DESCRIPTIVE REPORT

Registry No. H11362

General Locality Cape Decision

Sublocality Decision Pass

Figure 2. H11362 and H11209 Junction Surfaces.

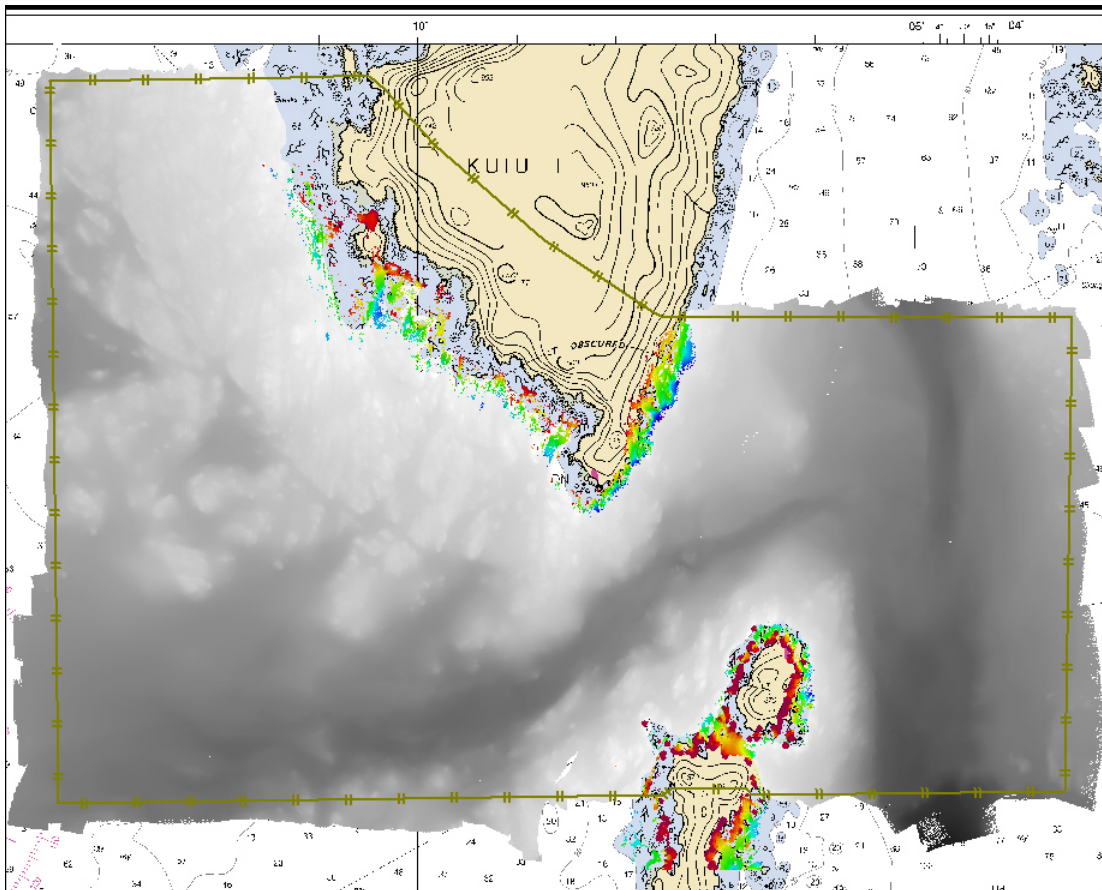
In areas where there was adequate overlap between the H11209 lidar and H11362 multibeam data, agreement between project soundings were generally within 0.25 m in areas with flat sloping bottoms. In areas containing rock outcroppings on the east side of Kuiu Island multibeam was generally 0.5 to 2 meters shoaler than the lidar⁶.

In near shore areas some lidar soundings are shoaler than multibeam soundings by up to 3 meters. These lidar soundings generally have depths of 0 to 2 meters⁷.

⁶ Concur

⁷ Do not concur. The multibeam data does not go inshore of the 8m curve and does not overlap with lidar data in areas shoaler than 2 meters. There is lidar and multibeam data over one rock shoaler than 2 meters; however the multibeam data is shoaler.
